MOTOROLA
Semiconductor Products Sector

Order Number: MCF5307UMAD/D
Rev. 0, 1/2001

Errata to ***MCF5307 ColdFire® Microprocessor User's Manual***

Figure 1. Undershoot Voltage

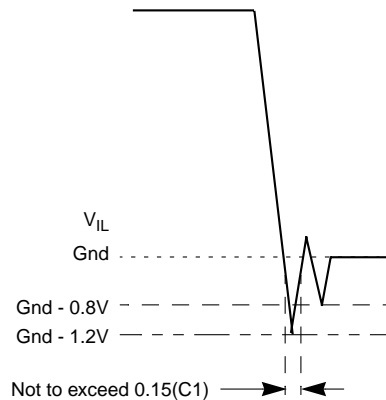
Section #/Page #	Changes
12.5.2.1, 12-13	Add the following text: NOTE: Use the CPU to write to the UART transmitter buffer. The DMA module is not able to properly transfer information from memory to the UART.
12.5.2.2, 12-13	Add the following text: Do not use single address access mode in cycle-steal mode; errant accesses may occur.
18.9, 18-23	Add the following text: NOTE: Either do not allow external master access to SDRAM using the MCF5307 DRAM controller or provide external termination for SDRAM bus cycles by an external master. The MCF5307 does not provide correct termination for external bus masters using the on-chip SDRAM controller.
20.1 20-2	Add the following diagram and text: Figure 1 shows the allowable undershoot voltage on the MCF5307. Note that 1.2-V undershoot is only allowable if it is present 1% or less of the total processor operating time.
